**Government of India
Ministry of Railways
Research Designs & Standards Organisation
Manak Nagar , Lucknow - 226011**

MODIFICATION SHEET NO.RDSO/WAM4/171

Rewinding details of Siemens make of MCP type ILA6 186-6.

2.0 Application to class of electric locomotives. All electric locos which are fitted with Elgi Compressor TRC 1000 M and driven by Siemens make of motor type ILA6 186-6.

REWINDING DIAGRAM FOR SIEMENS
MAKE MCP TYPE ILA6 186-6

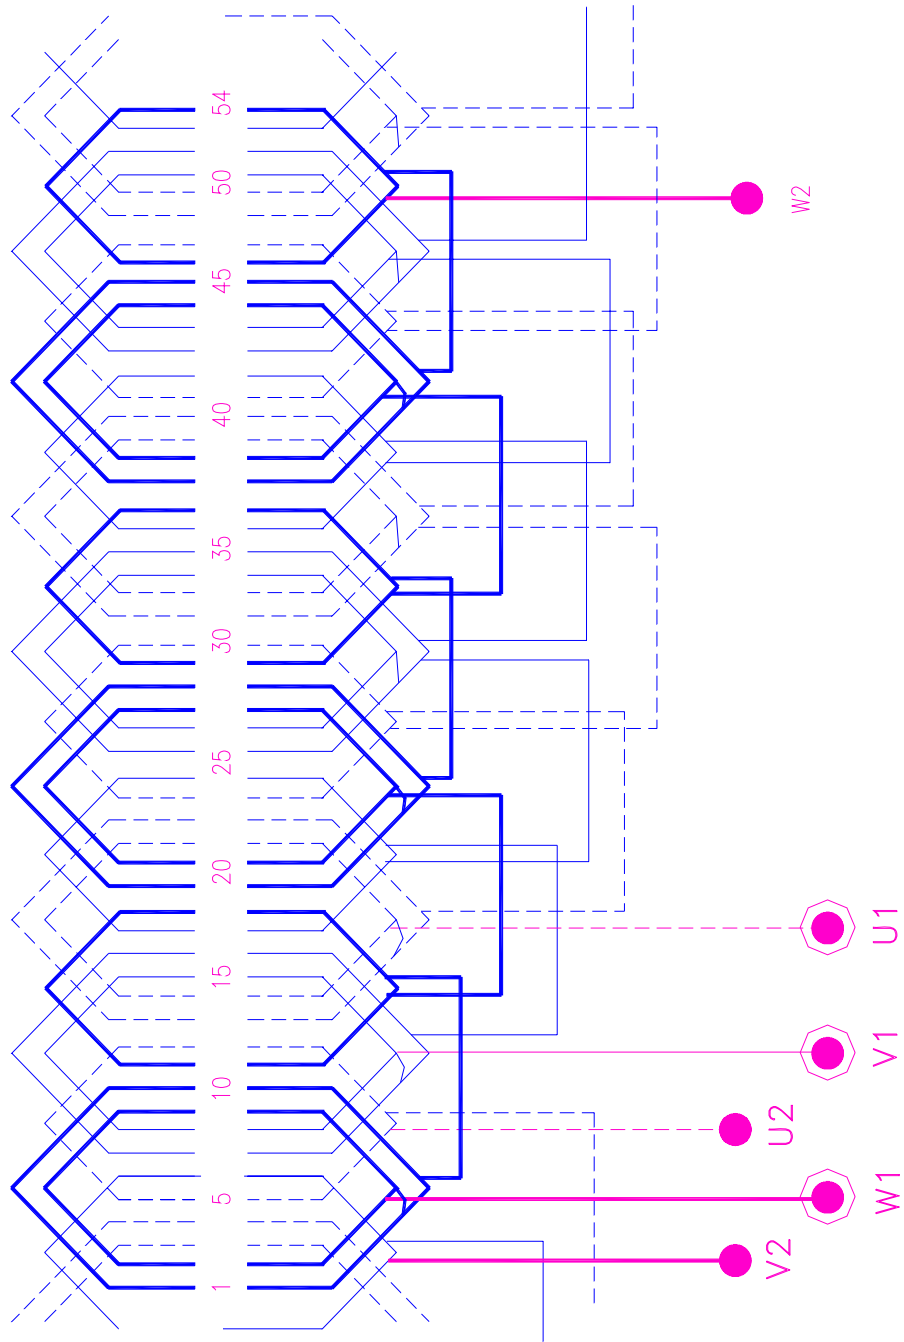
3.1 Railway have reported large number of failures of M/s Siemens make of motor during service on account of stator winding burnt. Detailed investigations in to the failure revealed that these motors have failed on lower voltage i.e. below 320V due to higher current density adopted with the glass covered enamelled copper conductor used for stator winding.

3.5 Modified stator winding will be suitable from 290V-500V to take care of problem of low voltage reported by Railways.

5.2 Following rewinding data shall be followed.

1.	Type of winding	-	Single layer
2.	Slot/pole/phase	-	2+1
3.	No. of coils	-	27
4.	Conductor per slot	-	12 (each conductor shall have 5 wires in parallel of size 1.0 mm dia i.e. 5 x 1.0)
5.	Wire size	-	1.0 mm (bare) 1.093 mm(insulated ie enamelled)
			0.785 mm ² (Area of one wire)
6.	Class of insulation	-	F
7.	Winding wire	-	i) Conforming to IS : 4800 Pt. IX ii) Conforming to IS : 4800
Pt.XIII			
8.	Copper Weight	-	9.00 kg. approximately
9.	Coil per phase in series	-	3
10.	Connection of phase	-	Star
11.	Coil pitch	-	9/9
12.	Coil Span	-	1-10/2-9; 11-18
13.	Total resistance for 3 phase	-	1.0427 at 20 degree C
